Application for Licence Amendment

Licence Number	L9440/2024/1
Licence Holder	Australian Garnet Pty Ltd
ACN	646 741 157
File Number	APP-0029371
Premises	Lucky Bay Garnet Project George Grey Drive YALLABATHARRA Legal description Tenements M70/1280, G70/253, L70/215, L70/134 and L70/178 within Lot 1 on Diagram 91564, Lot 300 on Plan 60565, and Lot 1431 on Plan 251608. As defined by the premises maps attached to the issued licence
Date of Report	15 January 2026 (FINAL)
Decision	Revised licence granted

This Amendment Report documents the assessment of potential risks to the environment and public health from proposed changes to emissions and discharges during operation of the Premises. As a result of this assessment, Revised Licence L9440/2024/1 has been granted.

Figure 1: In-pit settlement pond design

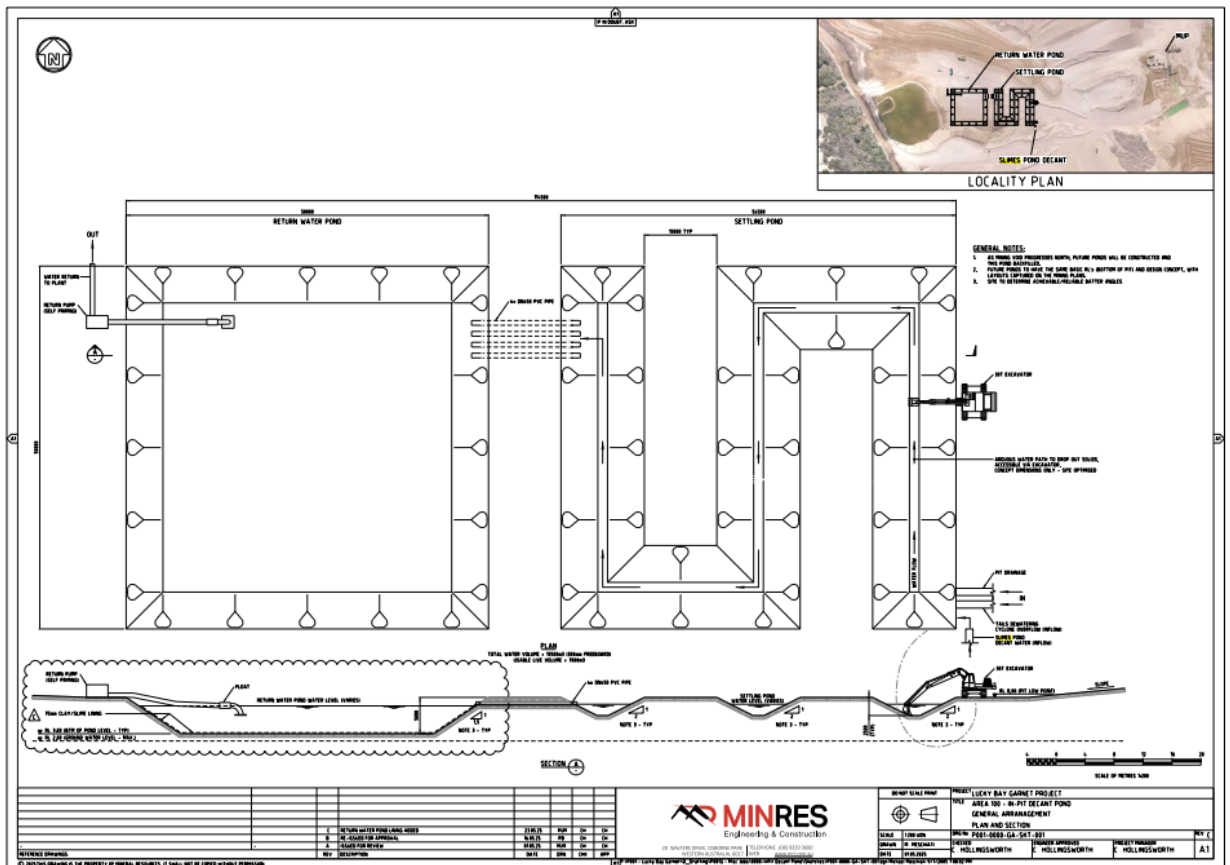
Water recovered from tailings cyclone overflow contains high levels of suspended materials. The Licence Holder proposes to construct and operate in-pit settlement ponds to receive tailings cyclone overflow, and decant water collected from solar drying ponds, to allow settlement of suspended material before recovery back to the processing plant for reuse (see Figure 1 below).

- Conceptually 50 m x 50 m x 5 m in size, to enable adequate settlement of fine material from the decant water;
- A minimum freeboard of 300 mm will be maintained at all times;
- Windrows constructed from in-pit fill of medium and small oversize from the Mobile Mining Unit (MUP) and tailings;
- A minimum separation distance of 1.0 m will be maintained between base of pit and the highest seasonal groundwater level;
- Base and sides of each pit will be lined with 75mm thick clay fines. Settled fines from the recovered water will also assist in minimising seepage due to the self-sealing nature of the settled material.
- Decant box located inside each pond for recovery of water for reuse at the processing plant; and
- Pipelines fitted to transfer decant water to the plant.

Figure 2: Distance to sensitive receptors

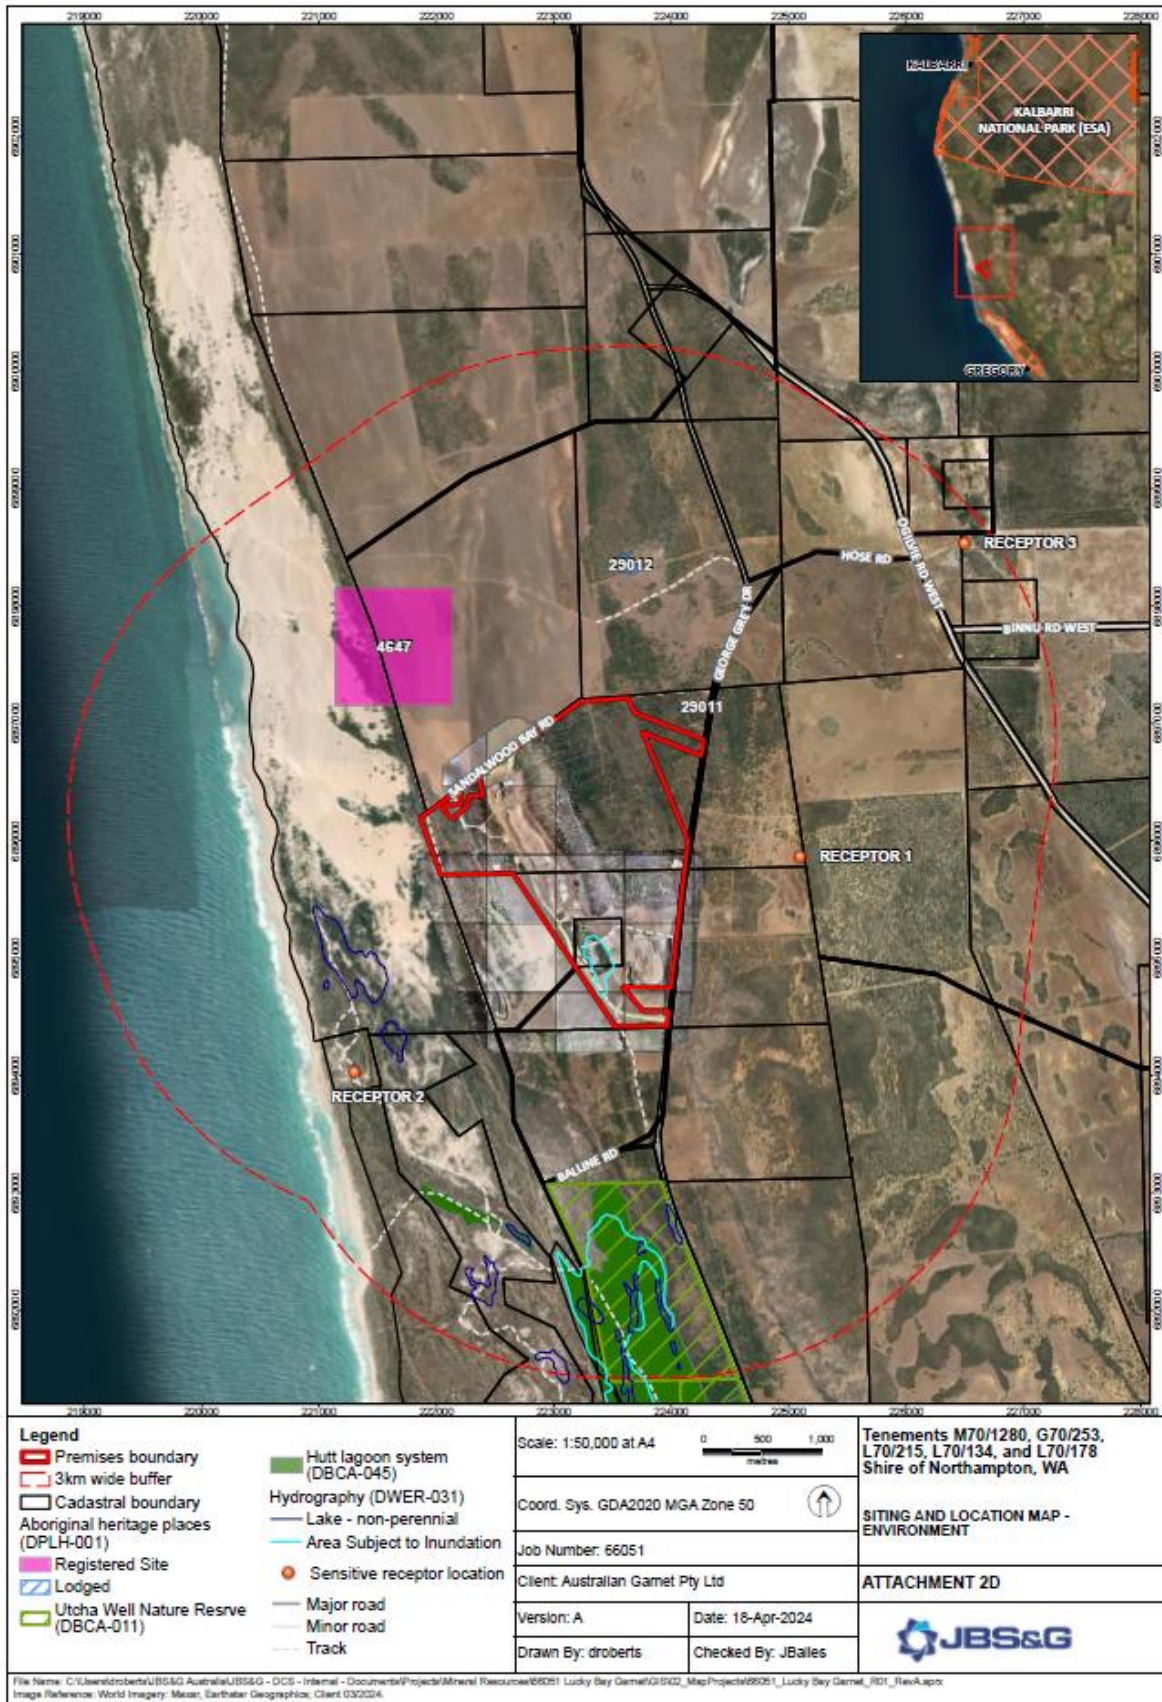
<p>Email to DWER dated 29/07/2025 and following up meeting held with Yamatji Southern Region Corporation (YSRC) on 2 August 2025</p>	<p>YSRC email comments provided 29/07/2025.</p> <p><i>YSRC has concerns that the Lucky Bay campground—located just 0.83 km west of the mining operation and identified in the Yamatji Indigenous Land Use Agreement (ILUA) as a key</i></p>	<p>1. The department originally grouped campground and shack receptors as one potential human-health receptor for the purposes of the risk assessment process. The department now however acknowledges the separation distance between the</p>

<p><i>economic site—has been grouped with the more distant Halfway Bay shacks (2.26 km away) for assessing sensitive receptors.</i></p> <p><i>This grouping potentially underestimates the campground's exposure to dust and noise impacts, especially given its closer proximity and alignment with prevailing wind patterns. Notably, the EPA recommends a minimum 2 km separation buffer for mineral sands mining operations, and the campground clearly falls within this buffer.</i></p> <p><i>We respectfully request DWER provide clarification on:</i></p> <ol style="list-style-type: none"> <i>1. The rationale for grouping the campground with the more distant Halfway Bay shacks;</i> <i>2. Whether this grouping is consistent with EPA guidelines;</i> <i>3. What additional monitoring or reassessment will occur to ensure impacts on the campground are adequately managed; and</i> <i>4. Why conditions 15–20 and 28–30 were removed from the final licence, specifically in relation to noise, dust, and groundwater impacts.</i> <i>5. Whether the buffer associated with the neighbouring licence area presents a risk to YSRC's ability to improve and further develop the campground.</i> 	<p>two receptors and therefore has assessed Lucky Bay campground and Halfway Bay shacks as separate receptors.</p> <ol style="list-style-type: none"> 2. N/A. See above comment 3. The licence was recently amended (31/10/2025) to strengthen conditions relating to monitoring ambient air quality, inclusion of an additional dust monitoring station, requirement to submit an interim dust management plan and provide a revised dust management plan by 31 March 2026. 4. Regulatory controls relating to managing noise, dust and groundwater impacts remain as conditions in the licence. 5. Land use planning and environmental approvals are different statutory processes. The Department's statutory roles and functions under the EP Act may intersect with the land use planning functions of State and Local Government (and the State Administrative Tribunal on appeal) and often environmental and planning approvals are required at similar times. A decision under Part V of the EP Act on an assessment of an application may be made prior to the final determination of a planning application. However, the Department recognises the importance of land use planning in the context of the delivery of appropriate public health and environmental outcomes and will have regard to the processes and views of other authorities in its decision-making process.
